Confidence Knitwear Ltd.

South Dhanua, Nayanpur, Maona, Sreepur, Gazipur.
(24.255162, 90.389317)

29 April 2014

Observations

No fire protection to first floor in Building 2

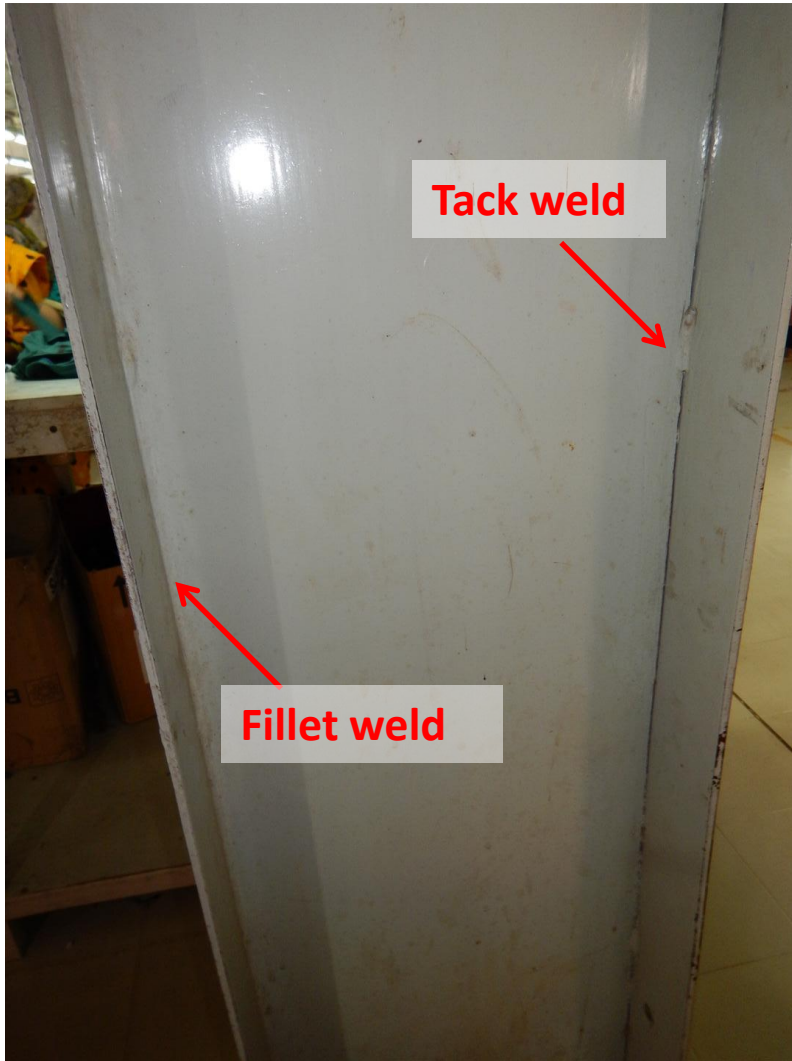
No visible fire protection to steelwork supporting first floor in Building 2.

First floor in Building 2 houses cutting, printing tables and storage.

14	Fire protection to first floor in Building 2	Building Engineer / Fire Engineer to advise on requirements for providing fire protection to steel elements to meet code requirements.	6-months
15	Edge protection to roofs	All roofs directly accessible by stairs to be provided with handrails or parapets around all edges.	6-months
16	Steel Construction	Steelwork connections throughout all buildings to be reviewed by engineer and recommendations made for adjustment.	6-months

Steel construction

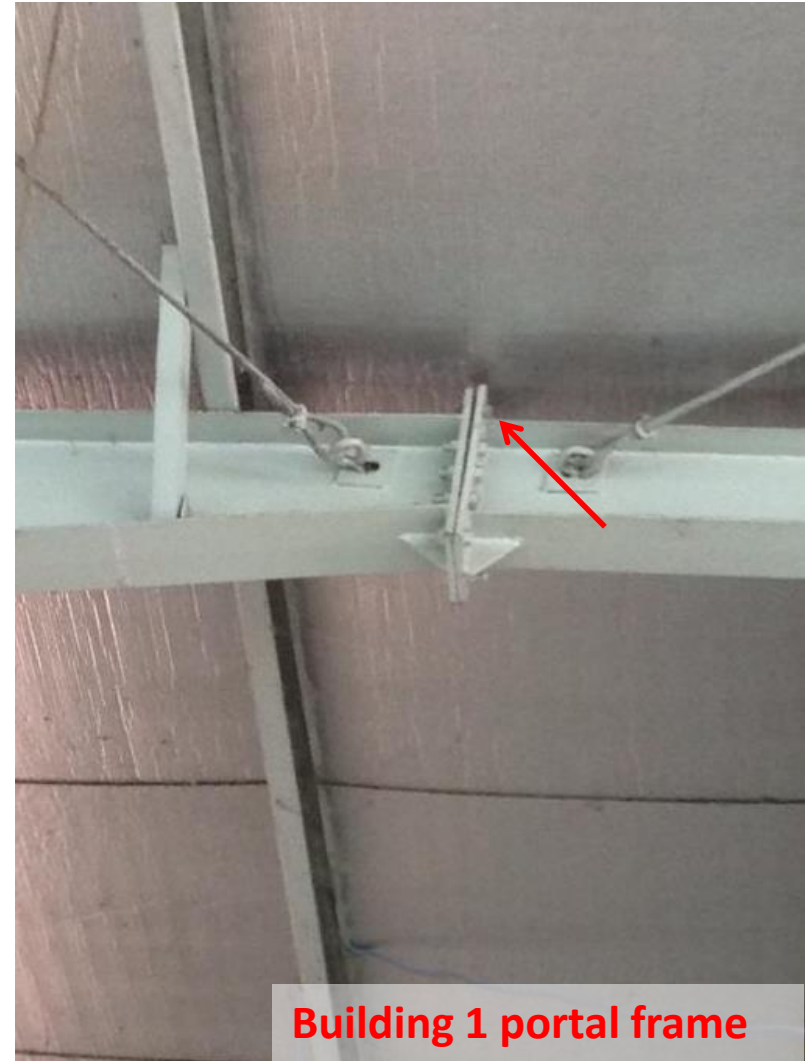
Building 1 columns comprise of built up sections fillet welded on one side and tack welded on the other.

Building 2 columns fully fillet welded, beams fillet welded on one side and tack welded on the other.
